REFERENCE	BT_2010_FR20_21_UK
DATE	14 th September 2010
SUBJECT	Clutch bleeding & new clutch releaser, central wooden floor thickness control, pad retaining bolt regulation
PART	Clutch circuit, central wooden floor, brake calliper

Mechanism without original ring

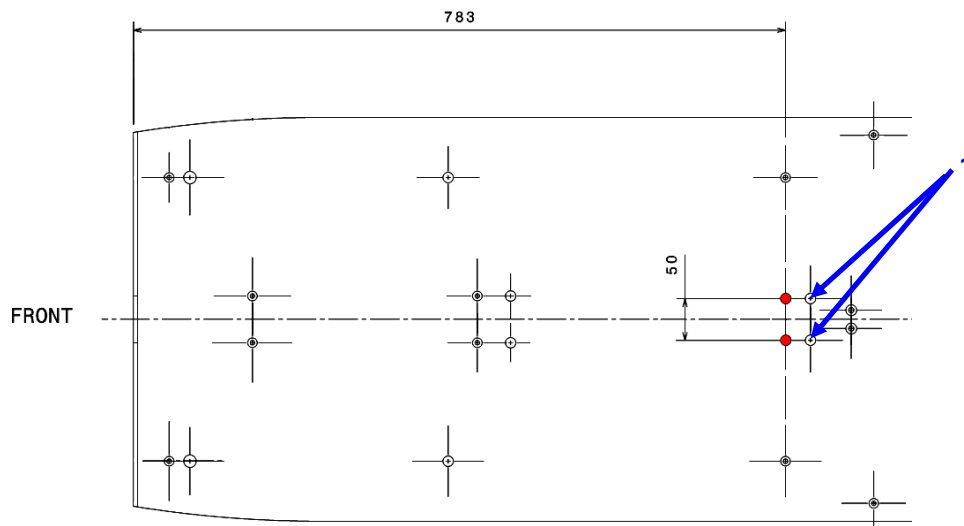
To use this new releaser, it is necessary to remove the central ring (1) from the clutch diaphragm. Without this ring, the mechanism is now more reliable. This ring is replaced by the one which is directly bonded on the clutch releaser.

As a consequence, to use this new releaser you must remove the central ring from your original clutch mechanism. To remove it, you simply have to break the elastic washer (1) which is behind the diaphragm:

The reference of the upgraded clutch releaser (with the bonded ring) is 77 11 166 678.

The reference of the upgraded clutch mechanism (without the ring) is 77 11 166 679.

The new holes are in red

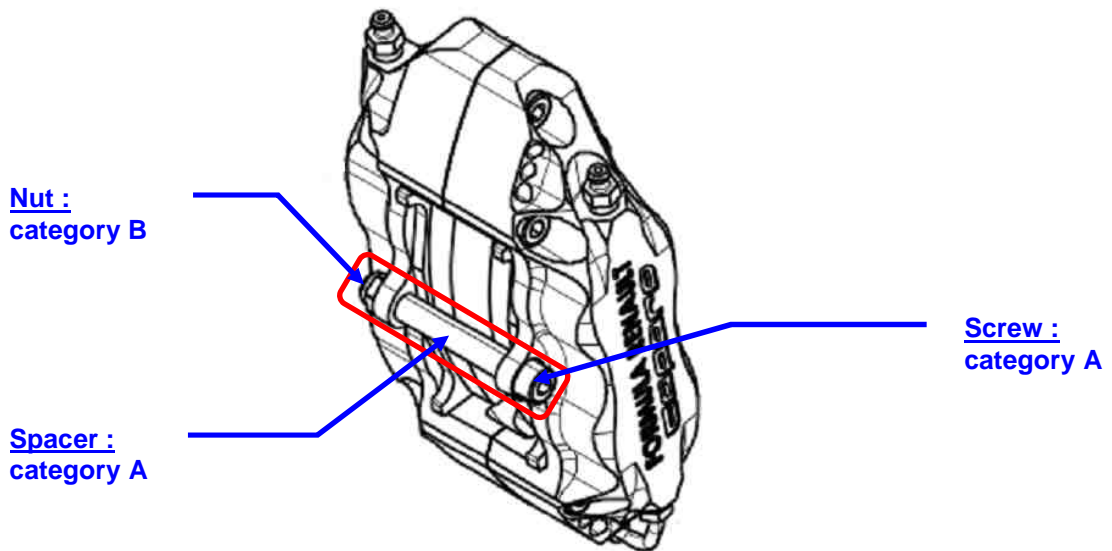
2 new holes must be drilled in the central wooden floor in order to check its thickness. The holes (1) previously used to check the plank thickness won't be used anymore.

These holes must be drilled between $\varnothing 10$ and $\varnothing 15$ mm and you must respect the following quotations:

This modification is mandatory from 21st of September, 2010.
